To: President of the Aurora Highlands Civic Association (AHCA), Cory Giacobbe  
From: AHCA Zoning Committee, Stacy Meyer, *Chair*  
Date: November 3, 2022  
Re: Americana Hotel Redevelopment, 1400 Richmond Highway

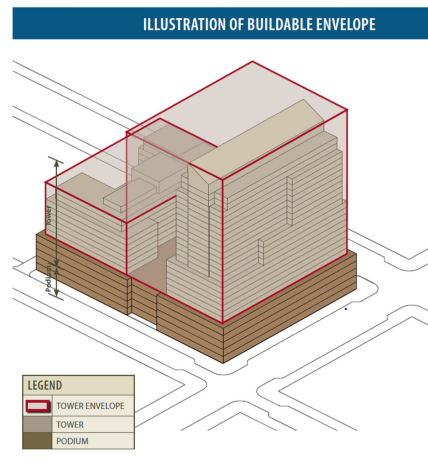
2. According to the staff report page 27, “the features and amenities that benefit the community have yet to be determined”. The increase in density being requested is large (+300K SF), and an understanding of the community benefits must be understood as part of the approval process. Aurora Highlands parks, schools, library, community center, etc. are in need of improvement and expansion to serve the increasing population.
3. The current proposal does not appear to taper to the west as per the CCSP. The current rendering does not appear to show much tapering at all. The apparent lack of tapering is a concern to the AHCA zoning committee.

5. What community benefits are described as part of the development, particularly given the proposed increase in density? What are the local benefits to impacted 22202 versus countywide benefits?
6. How does the building meet the tapering requirements and other requirements of the CCSP for development? What measures is the county taking per the CCSP?
7. What is the rationale for less parking and no retail parking?
8. What studies have been done that ensure the proposed parking sharing is adequate for residents?
9. What data supports the parking assumptions?
10. What is the traffic LOS and pedestrian safety that is projected for the cumulative development along Route 1 and Eads?
11. Why is a block plan not required?
